SITE PLAN REVIEW

- * Date Submitted _____
- * Scheduled for P&Z 11/12
- * Scheduled for Council 12/17
- * Applicant/Owner Waipae Backus
- * Name of Proposed Development Mobil Car Care
- * Location 740 / Yellow jacket * Legal Description Goldencrest
- * Total Acreage _____ * No. Lots/Units 1
- * Current Zoning C/OD
- Special Restrictions OD restrictions
- * Surrounding Zoning C

Case No: 87-47-SP/COPLocation: FM 740 / Yellowjacket

Architectural Review Board Site Plan
Comments and Questions

AUTOMOTIVE SERVICE CENTER
 REVISED SCHEMATIC

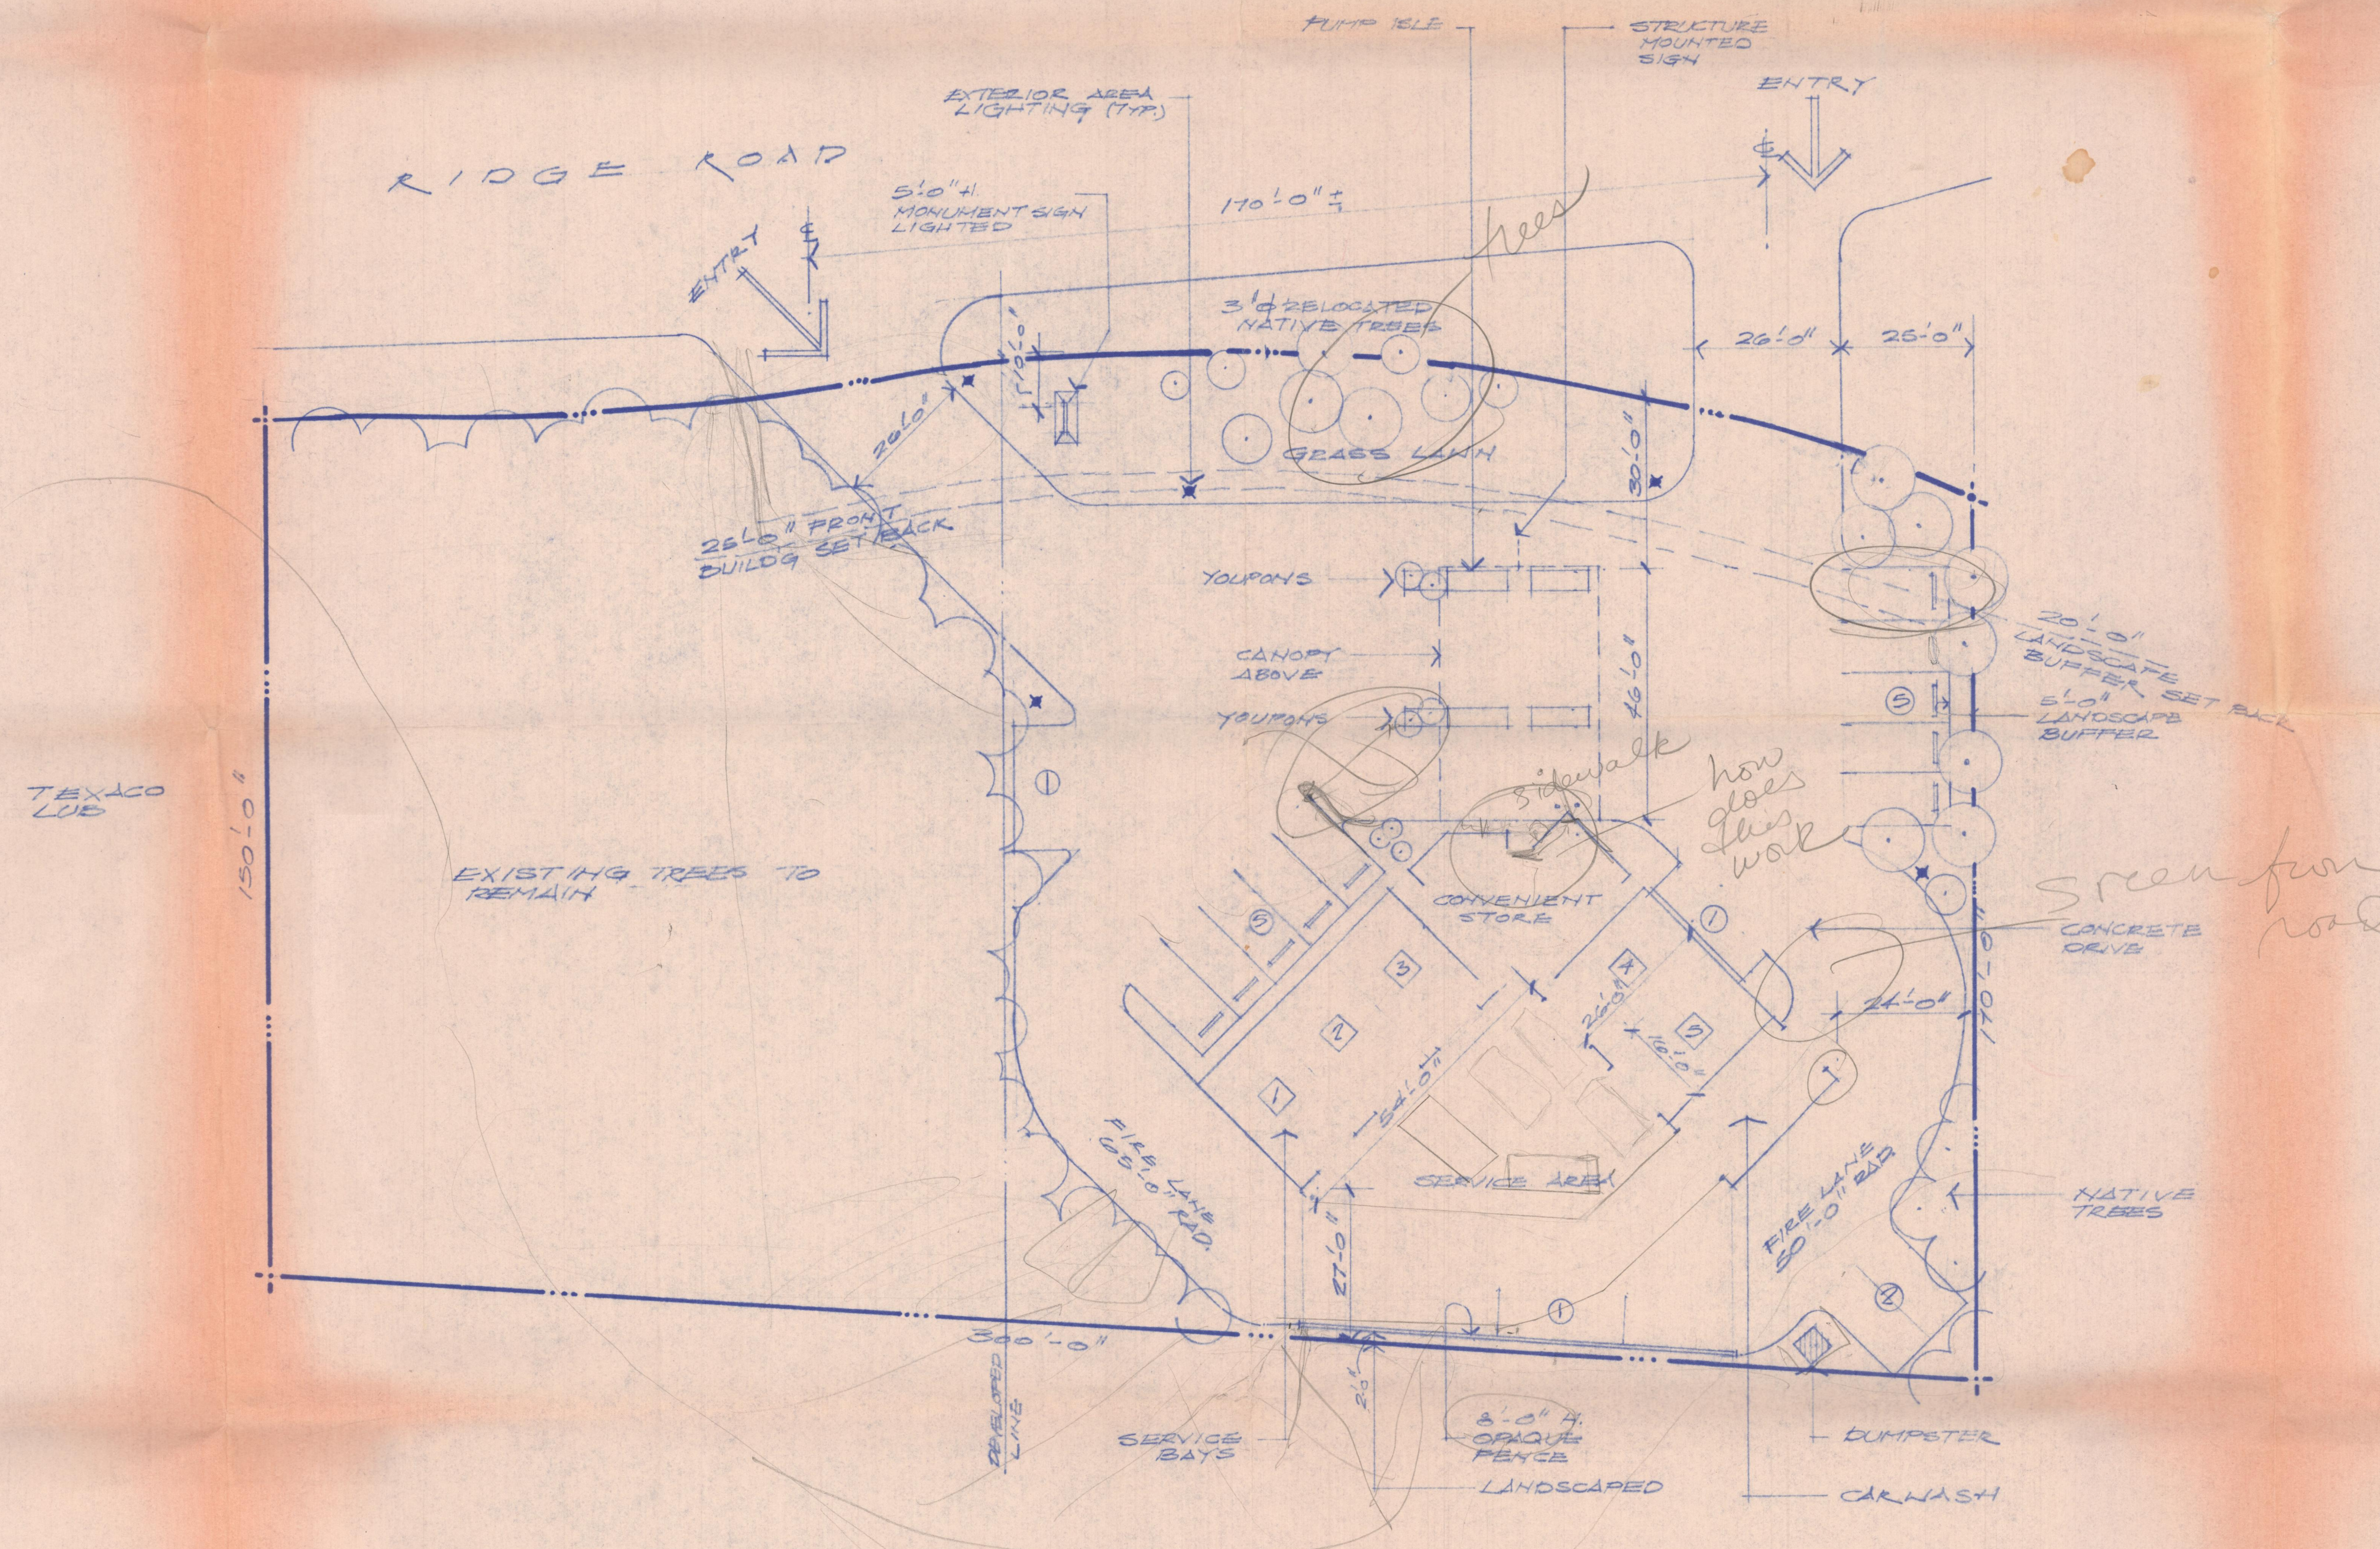
roof line
 brick wall
 no windows
 more parking spaces
 steeper - more regional
 less geometry
 pitched roof
 post modern look

AUTOMOTIVE SERVICE CENTER
REVISED SCHEMATIC

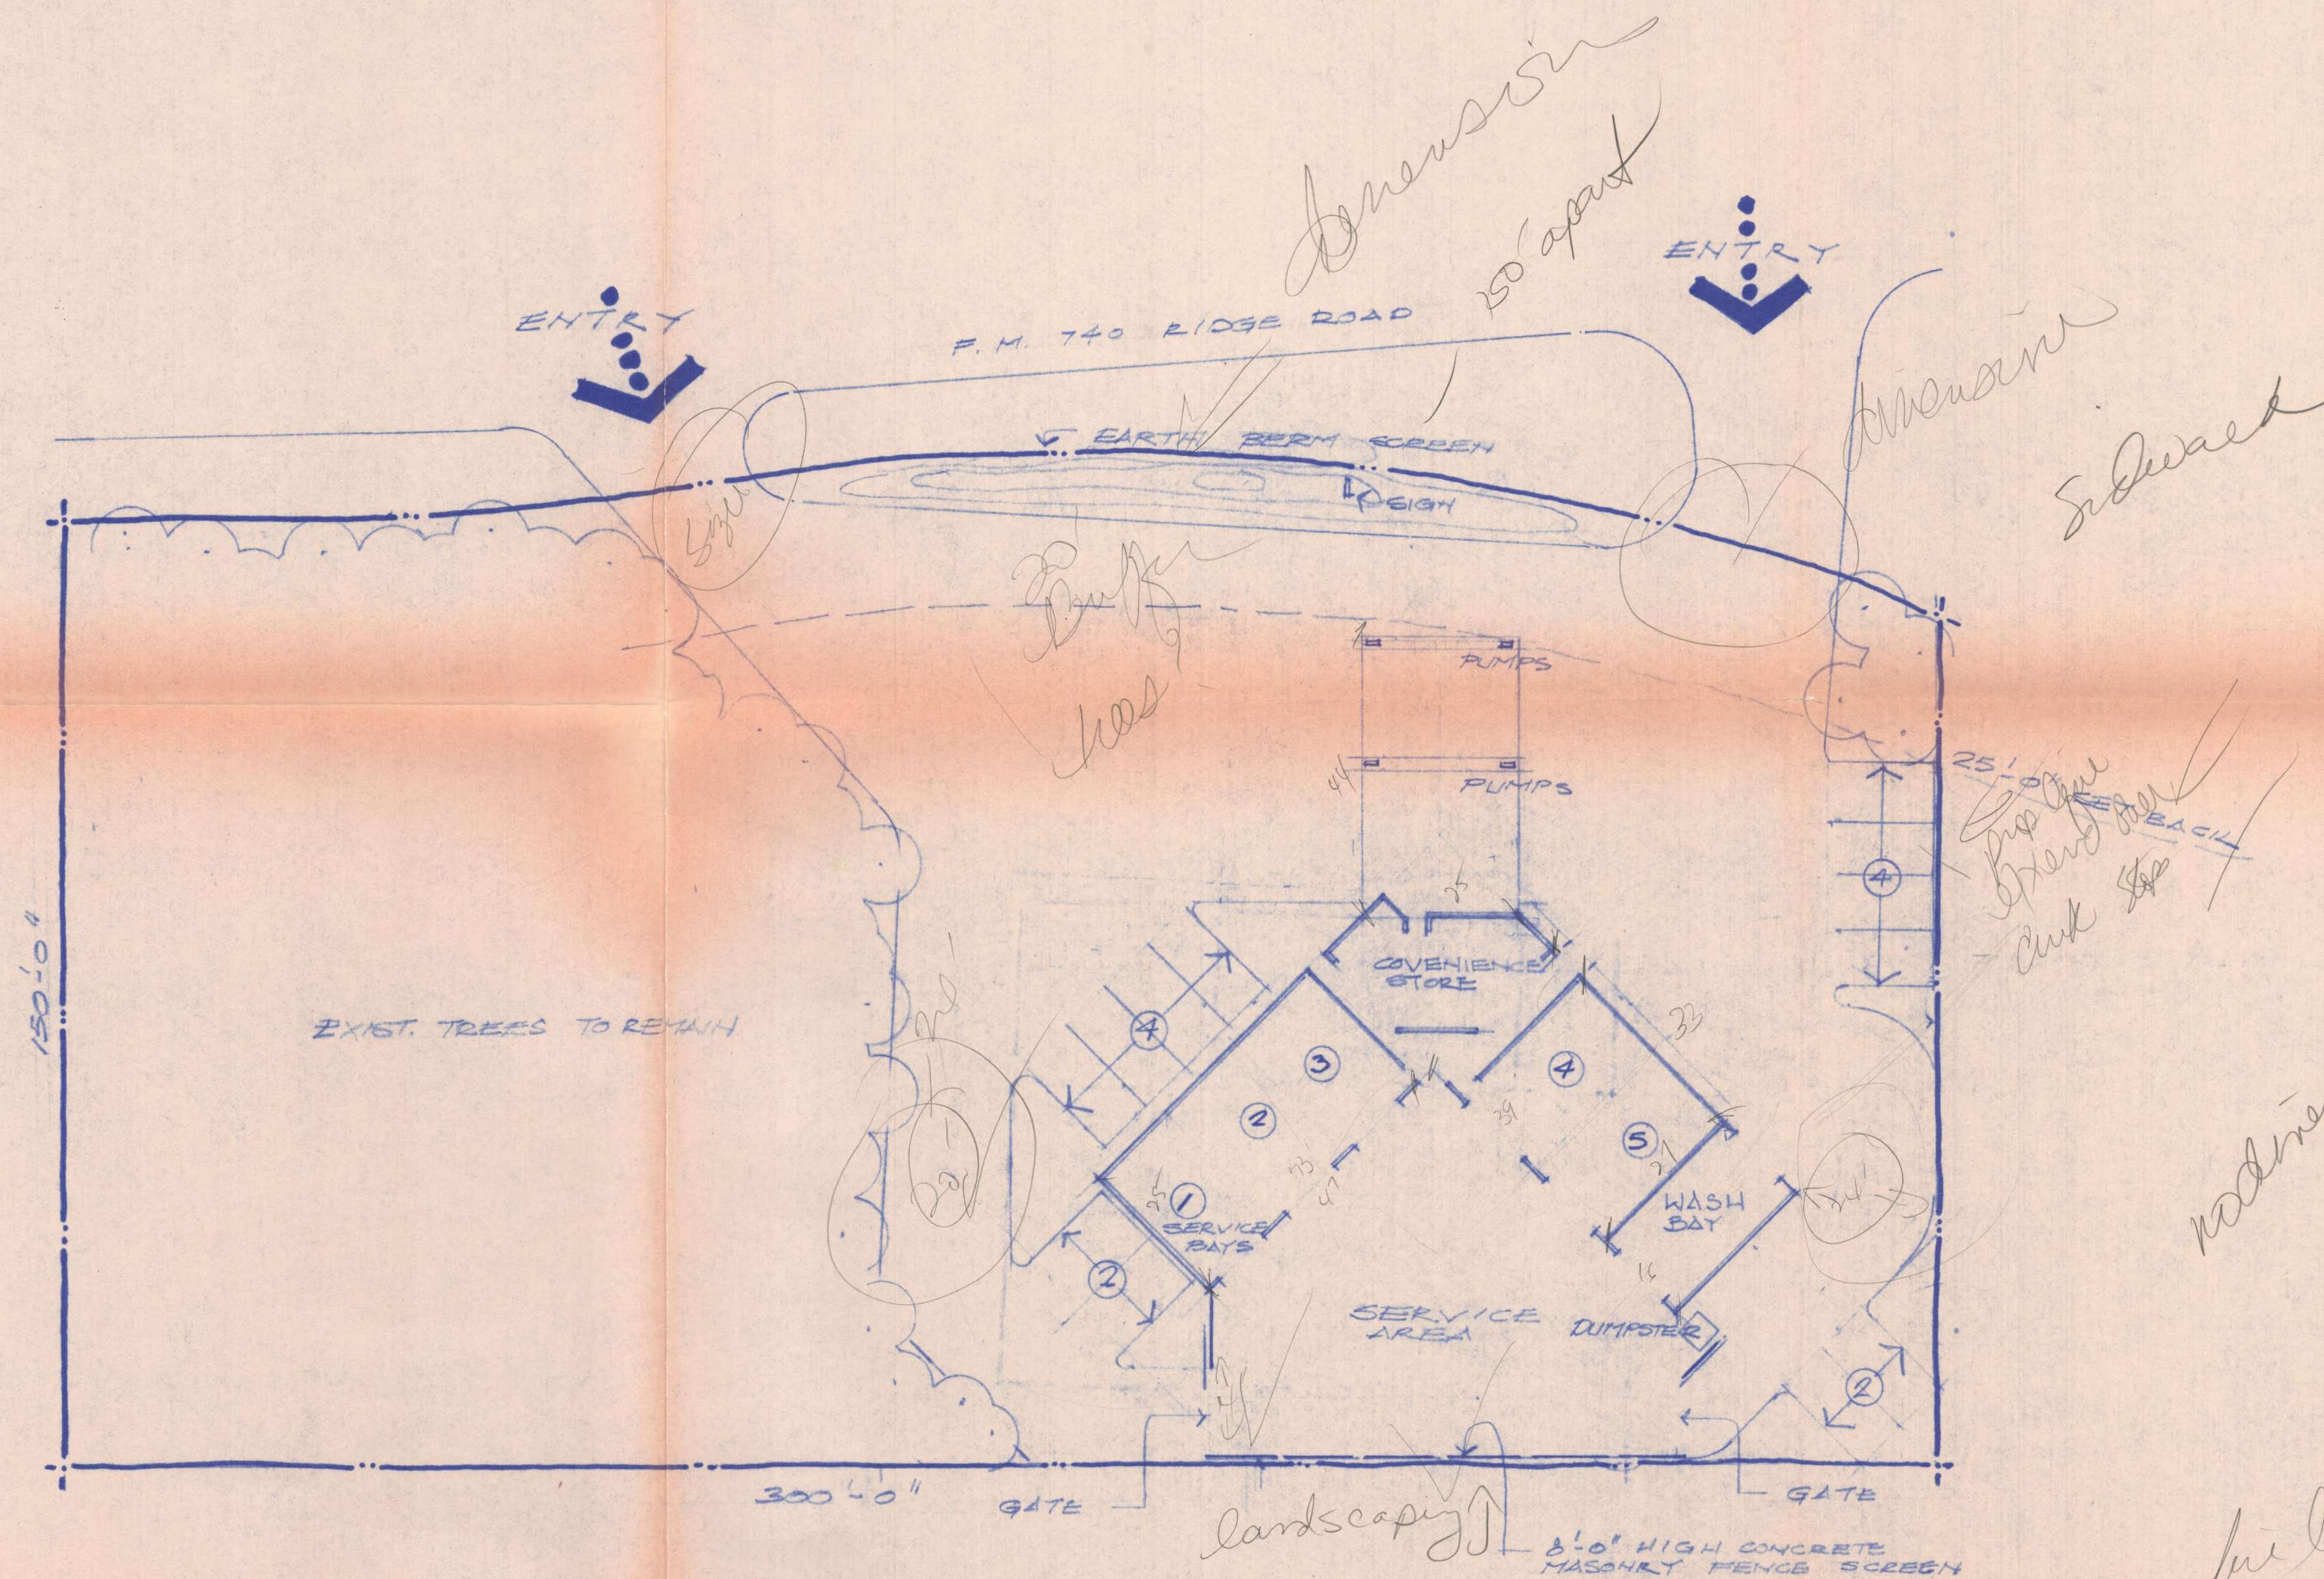
want trees to be marked
15 ft radius
